# Department of Environmental Quality

**Re: Summary of March 2014 Inspection, Lost Creek ISR Project, Permit #788**

**Wyoming Department of Environmental Quality (WDEQ)- Land Quality Division (LQD)**  
**Inspection Memorandum**

File: Lost Creek ISR, LLC – Permit 788

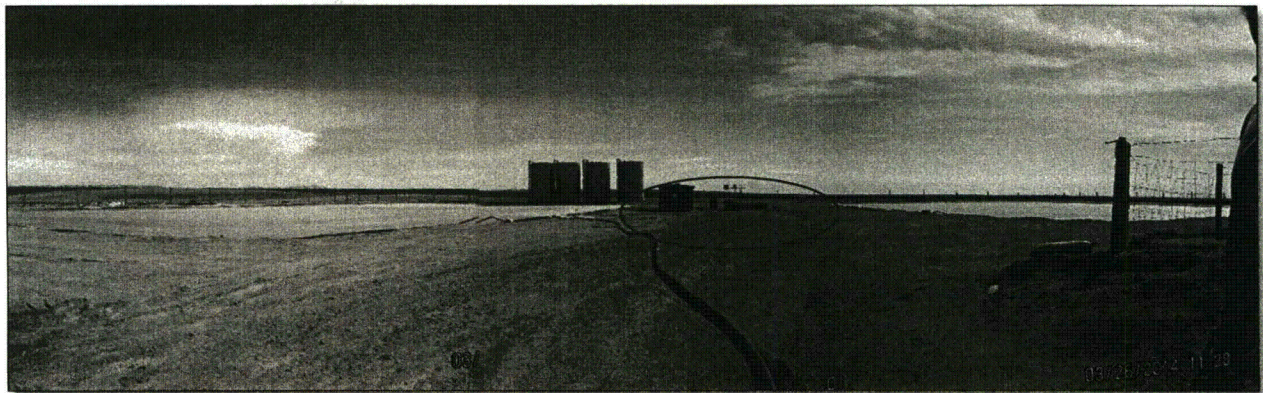
During this Inspection, the spill that occurred on March 20, 2014 was briefly discussed. This spill occurred in the ponds area while water from the plant was being piped to one of the ponds. Mr. Gaither indicated he was in the final stages of assembling the spill report for this spill, as the report is due on March 27, 2014.

Upon ocular inspection of the ponds (from the conference room window) it was discernable that the ponds were quite full. A review of the most recent pond inspections (provided by Mr. Gaither) indicated the ponds' freeboard is currently at 1.5 feet. The permit requirement for the ponds' freeboard is three (3) feet.

LCI will be emptying the ponds promptly in light of this. It was noted that the about 90% of the ponds' surfaces are still covered with ice, so wave action is not yet a concern. However, the spring thaw is forthcoming and the ice will not remain much longer. **The need to reduce the water levels in the ponds is a new top-priority action item whose deadline is immediate.** LCI personnel are asked to inform LQD when the ponds' freeboard has been brought back to three (3) feet. This can be done electronically (via e-mail) with an accompanying copy of a pond inspection report.

- 1) Pump water out of the ponds to ensure they have at least 3 feet of freeboard (**deadline is immediate**),
- 2) Finalize the clean-up of materials in informal laydown area north of ponds (**deadline April 30, 2014**),

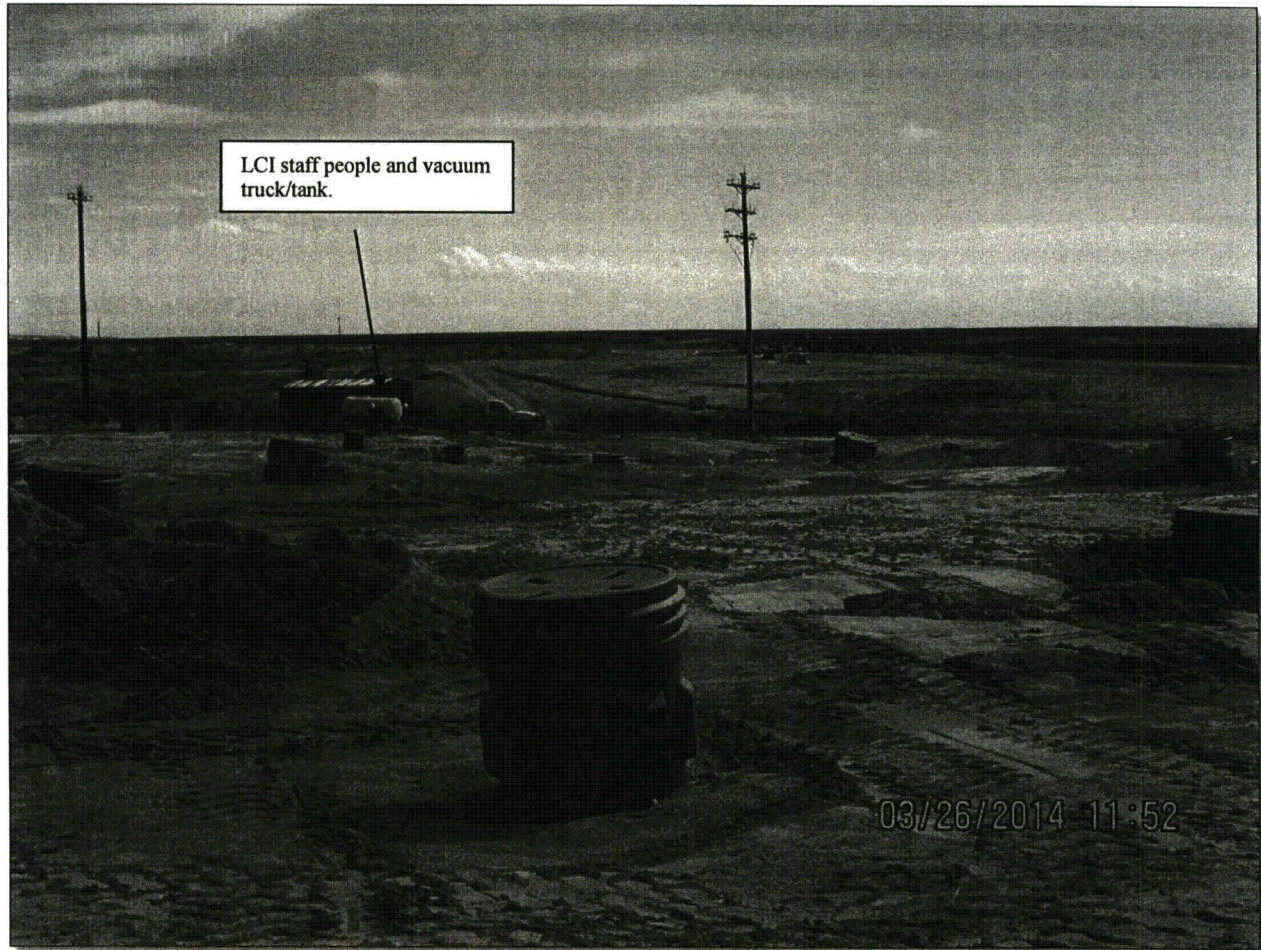
A spill in HH 1-5 occurred the day before this inspection. It appears to have been derived from a broken buried trunk line. During this Inspection, LCI personnel were in the process of recovering fluids from this spill and delineating it. Mr. Gaither indicated he was planning to call in this spill to the WQD Spill Hotline after this Inspection.

Two spills occurred at the site since the last Inspection; one on March 20, 2014 and another on March 25, 2014. LCI staff are in the process of submitting the spill report for the March 20<sup>th</sup> spill and were in the process of delineating and cleaning the spill that occurred on March 25<sup>th</sup>. LCI has handled spill reporting in accordance with the Permit to date and there are no concerns with LCI’s handling of the current spills. As of the mailing of this Inspection report, the spill report for the March 20<sup>th</sup> spill was submitted electronically to LQD by LCI’s Mike Gaither.
